August 21, 2020

**Technical Comments from Bell on the July 1, 2020 Supplemental Remedial Investigation Report, Orange County Water District, South Basin Groundwater Protection Project, Operable Unit 2 (Supplemental RI Report) prepared by Hargis + Associates, Inc. (Hargis) for the Orange County Water District (OCWD).**

The following technical comments on the Supplemental RI Report have been prepared on behalf of Bell Industries, Inc. (Bell).

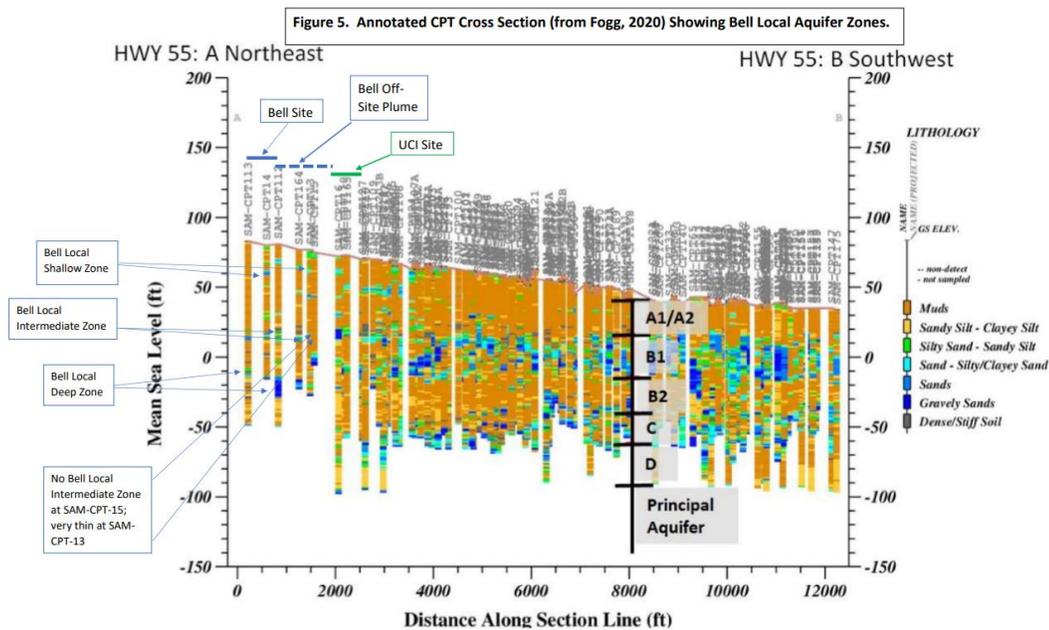
The three hydrostratigraphic layers in the vicinity of the Bell site are also clearly identifiable on Figure 4.3.4 of the April 23, 2020 Expert Report of OCWD Expert Graham Fogg, Ph.D. As noted by Dr. Fogg, his staff compiled a total of 22,369 feet of logs from 171 CPTS within the South Basin. The figure below, which is Figure 5 of the June 26, 2020 Expert Report of Bell Expert Dr. Andrew A. Kopania, PG, CH, depicts the Bell hydrostratigraphic layers relative to those previously defined by OCWD (A1/A2, B1, B2, C, and D) on Figure 4.3.4 from Dr. Fogg’s Expert Report. It is clear on Dr. Kopania’s Figure 5 that the shallowest interval at Bell (referred to as the Local Shallow Zone) projects above the ground surface toward the south and does not exist in much of the south part of the South Basin study area. Thus, the hydrostratigraphic zones are not necessarily continuous throughout the South Basin. Hargis appears to have abandoned the A through D aquifer zone designations used by other consultants and experts for OCWD and, in the process, over-simplified the subsurface conditions in a manner that results in incorrect correlations between units and misrepresents the continuity of those units across the South Basin.

Groundwater Contour Map-2012  
OCWD v. SABIC, et al.  
Figure 7

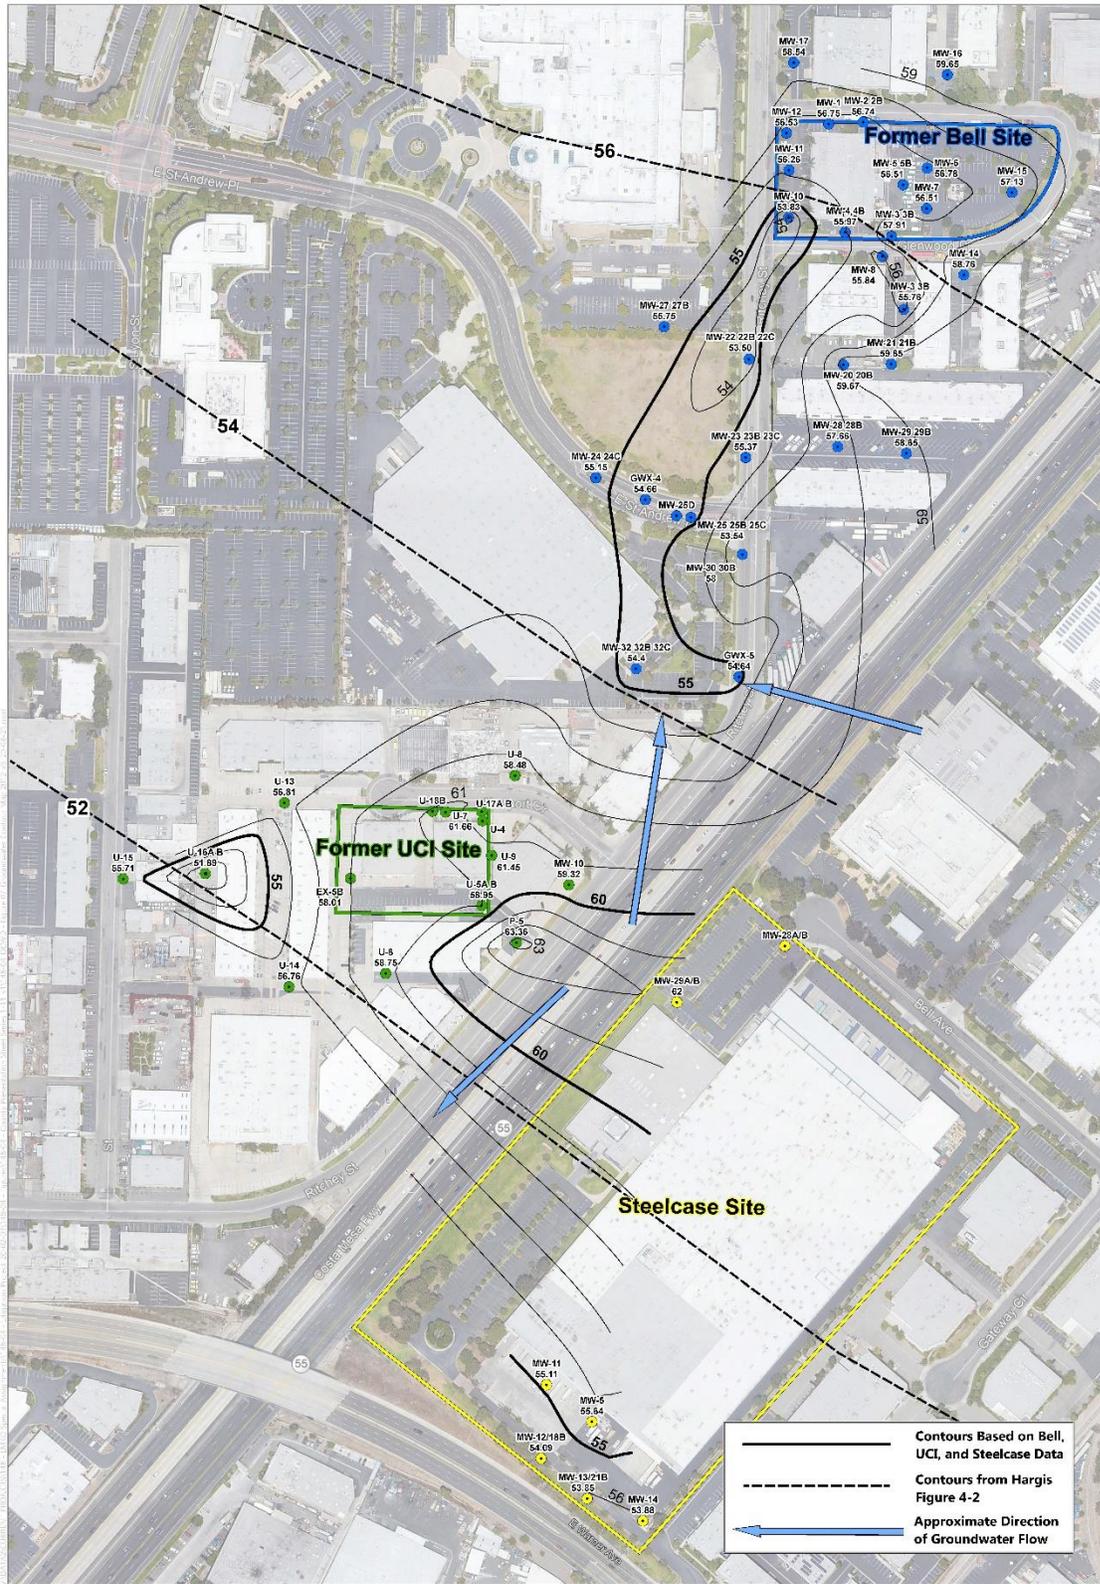
In any case, it is clear that Hargis did not use any of the voluminous data available from the individual source sites because the contours depicted by Hargis are dramatically inconsistent with the actual data from those sites. For example, the second figure below, which is modified from Figure 7 of the June 26, 2020 Expert Report of Bell Expert Dr. Andrew A. Kopania, PG, CH, shows the groundwater contours from Figure 4-2 of the Supplemental RI Report, for the Upper Portion of the Shallow Aquifer System for early 2012, superimposed on the groundwater contours from the same aquifer interval for the same time period based on local data from the Bell, UCI, and Steelcase sites<sup>2</sup>. It is clear from the depiction on the modified Figure 7 that the contours produced in the Supplemental RI Report are completely inconsistent with the actual water level data in the northeast part of the South Basin.

Furthermore, Figures 4-3, 4-5, and 4-7 of the Supplemental RI Report, which show groundwater contours for the Lower Portion of the Shallow Aquifer System, do not show any data or contours within several thousand feet of the Bell, UCI, or Steelcase sites. However, as noted above, there is voluminous data available from the lower part of the shallow aquifer system obtained over several decades from the northeast part of the South Basin.

Thus, it can be concluded that the groundwater contours presented in the Supplemental RI Report are based on a selective and dramatically incomplete set of data, which results in faulty depictions of groundwater flow and incorrect interpretations regarding groundwater flow and plume movement.
